TO : Parts & Service Managers    DATE : December 27, 2006

**Symptom :**

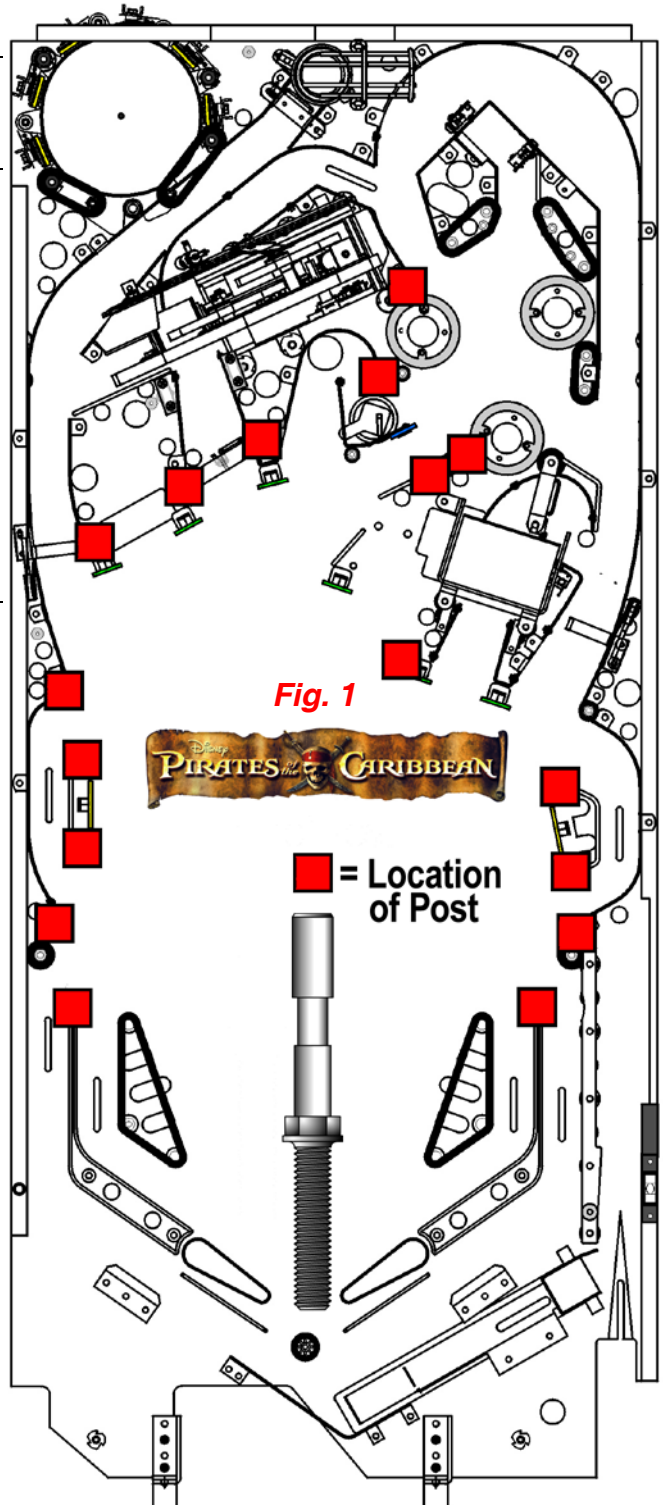
One or more playfield posts have become loose (see **Fig. 1**). After retightening the posts, they work loose again.

We have seen the 3/8" Nylon Stop Nut (#10-32), that secure 17 posts on the playfield (**Fig. 1**), become loose on some machines. This is caused by the nut not having enough thread to grab on the post due to normal variances in playfield thickness, washer thickness and post thread length.

**PLEASE NOTE: >>> NOT ALL POSTS ARE AFFECTED <<< HOWEVER, FIND ALL OF THE POSTS UNDER THE PLAYFIELD USING THE LOCATION MAP (FIG. 1) AND RETIGHTEN WITH A 3/8" NUT DRIVER. INSPECT THE NUTS TO ENSURE YOU SEE 1-2 THREADS THROUGH THE NUT; IF NOT, PERFORM SOLUTION BELOW.**
